HEBDEN SUBDIVISION

APPLICATION NUMBER 16 DATE May 17, 2007

HEBDEN SUBDIVISION

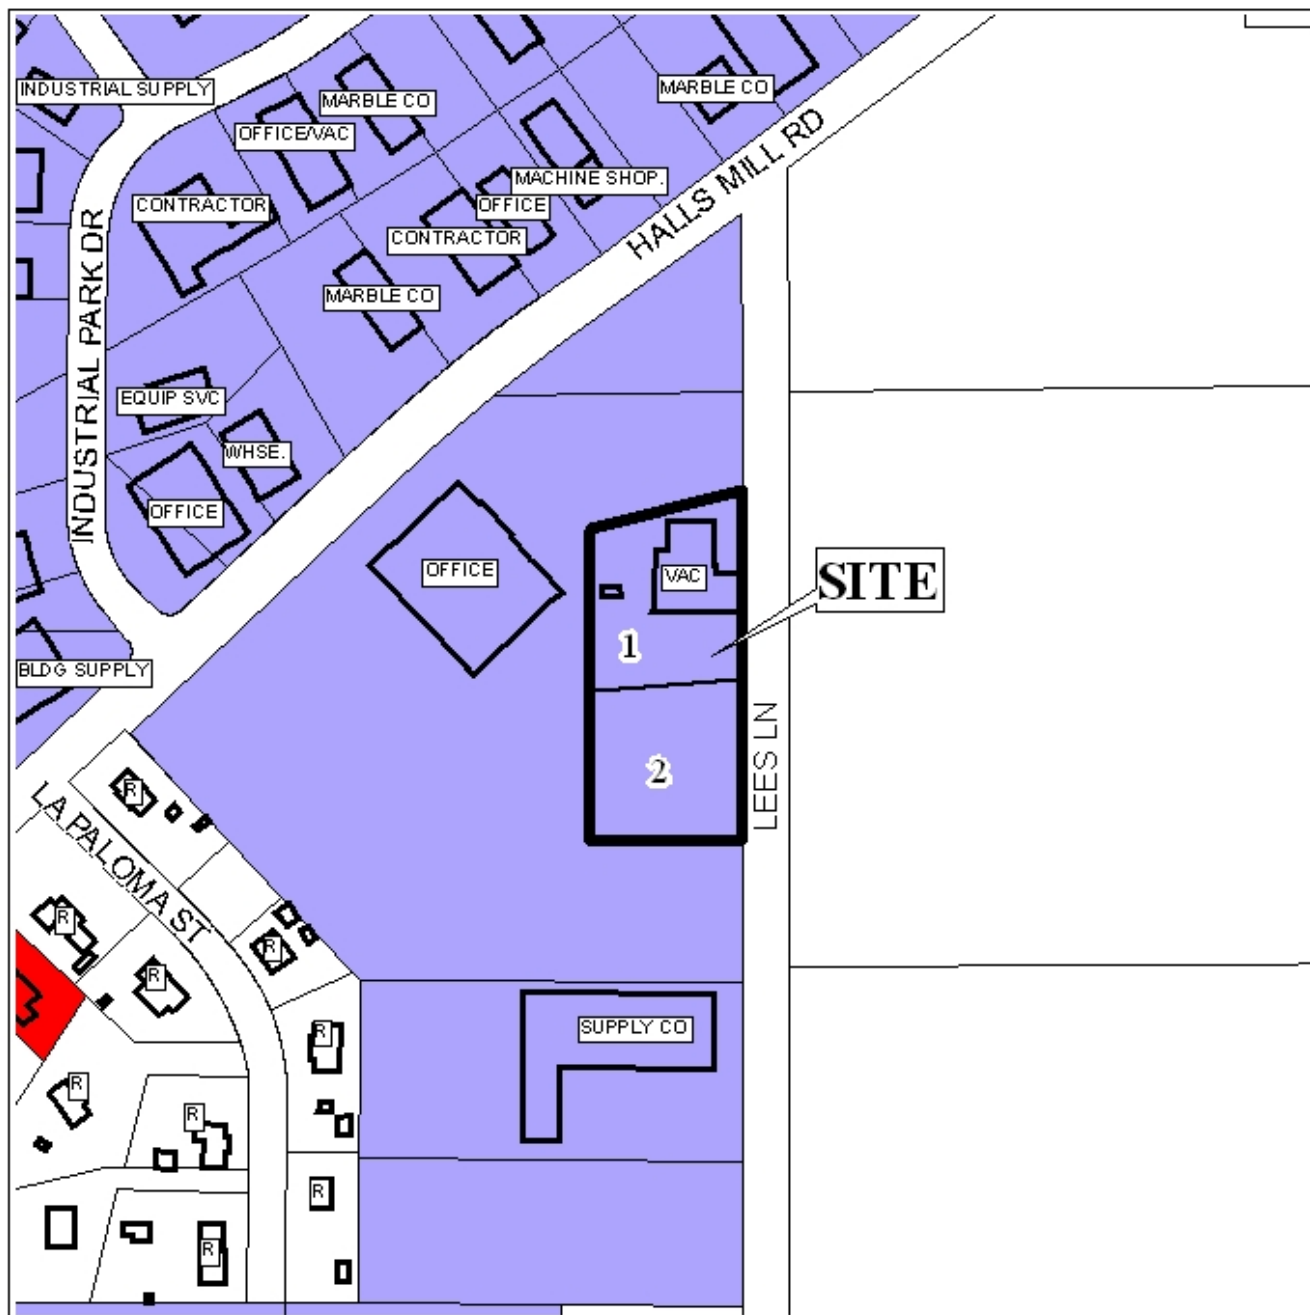
The 25-foot minimum building setback line is not depicted but would be required on the final plat, if approved.

All lots appear to meet the minimum size requirements of the Subdivision Regulations, however, the plat should be revised to label each lot with its size in square feet, or a table should be provided on the plat with the same information.

- 1) placement of a note on the final plat stating that each lot is limited to two (2) curb-cuts, with the size, design and location of all curb-cuts to be approved by Traffic Engineering and conform to AASHTO standards;
- 2) depiction of the 25-foot minimum building setback line;
- 3) revision of the plat to label each lot with its size in square feet, or provision of a table on the plat with the same information; and
- 4) full compliance with all municipal codes and ordinances.
